Mark Wear Ltd. (Pantalon Textiles Ltd.)

4th June 2014

Building Observations

Steel Stairs

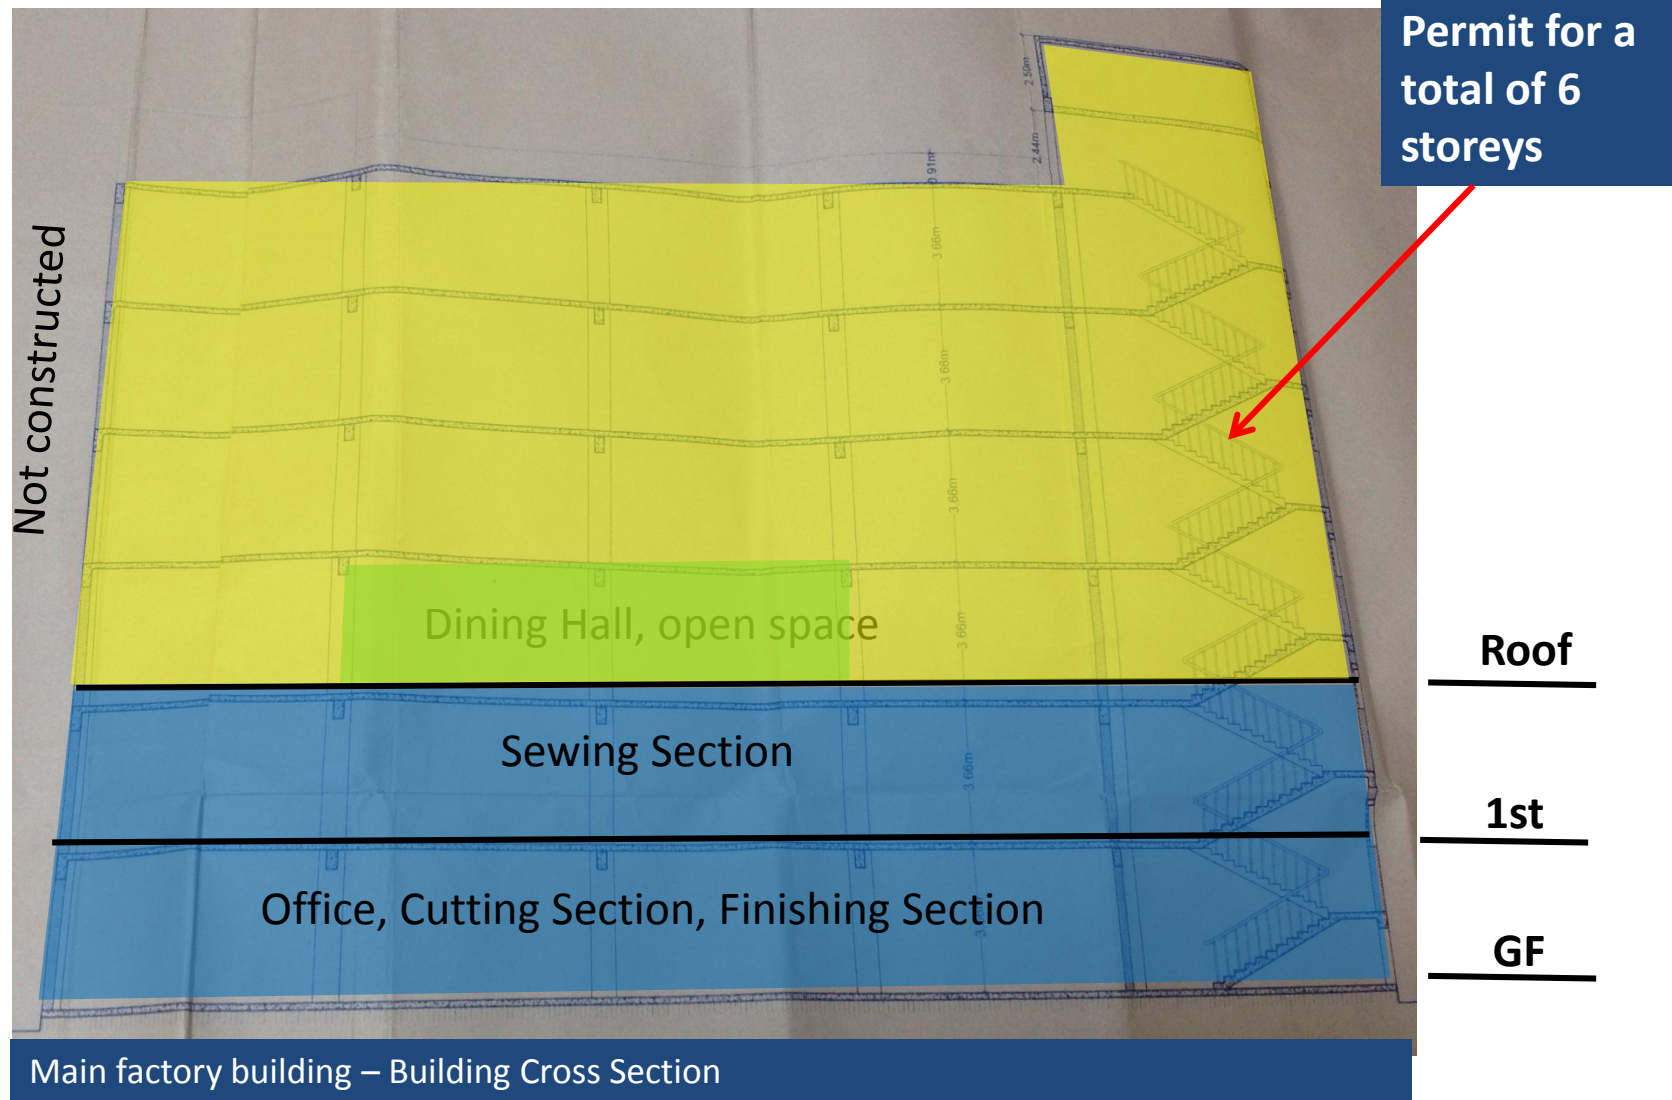
Connection details of steel stairs and deterioration of paint coating to welds

Steel stairs (emergency staircases for fire situation) located to the east and west elevation of the building. There are no steel drawings available for these stairs.

We note that all connection details appear to have been fully welded in-situ. Some of the welds which were available for inspection have rust marks. We also note that the paint protection for the steelwork has been touched up in the past, most probably because of premature failure.
